Certified Action of the City of Raleigh Planning Commission

Case File / Name: S-12-09 / Cranbrook Road Subdivision

Nature of Case: Reconfiguration and subdivision of 2 existing lots on .953-acres, BK 1954 PG 36, into 3 single-family lots zoned Residential-4. There are two existing houses on the lots that will be removed.

S-56-08 Cranbrook Subdivision – preliminary plan

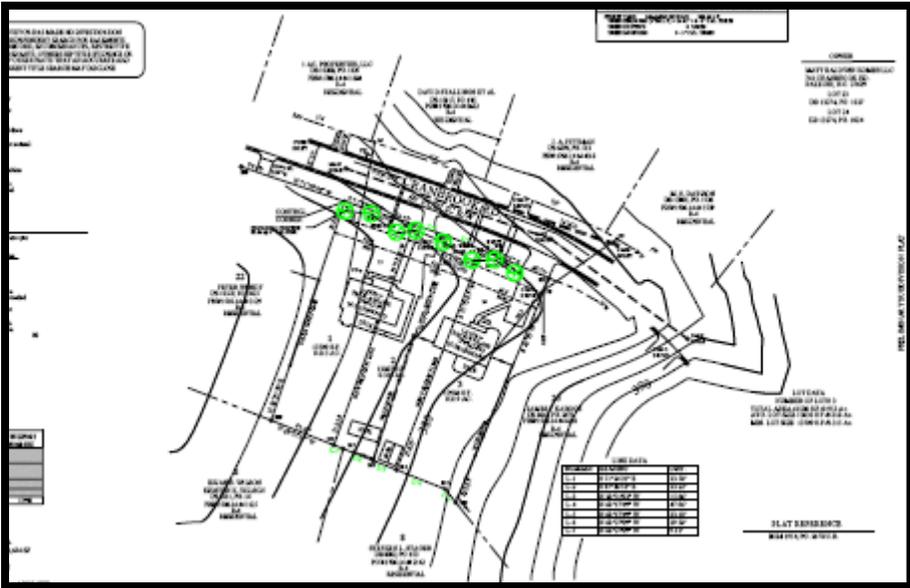
All 3 lots fail to meet 80% of the median road frontage and 80% of the median lot acreage of surrounding lots.

<u>Median lot size of surrounding lots</u>	<u>.49 acres (80% = .392)</u>
Proposed lot size lot #1	.315 acres (64% of median)
Proposed lot size lot #2	.319 acres (65% of median)
Proposed lot size lot #3	.319 acres (65% of median)
<u>Median lot frontage of surrounding lots</u>	<u>100' (80% = 80')</u>
Proposed lot frontage lot #1	66.72 (66% of median)
Proposed lot frontage lot #2	66.72' (66% of median)
Proposed lot frontage lot #3	66.72 (66% of median)

ADDITIONAL NOTES: The applicant offered a revised condition at the public hearing. The revised condition approved by Planning Commission was a 50' front yard setback to be congruous with the adjunct lots and this setback requirement will be for all three lots as approved in this subdivision. This setback is to be shown on all recorded maps.

- (13) That a fee in fee-in-lieu of construction for ½ of a 5' sidewalk along Cranbrook Road in an amount determined by the City Engineer, is paid in the Public Works Department;
- (14) That the 50' foot front yard setback to be congruous with adjacent lots and this setback shall be shown on all maps for recording;
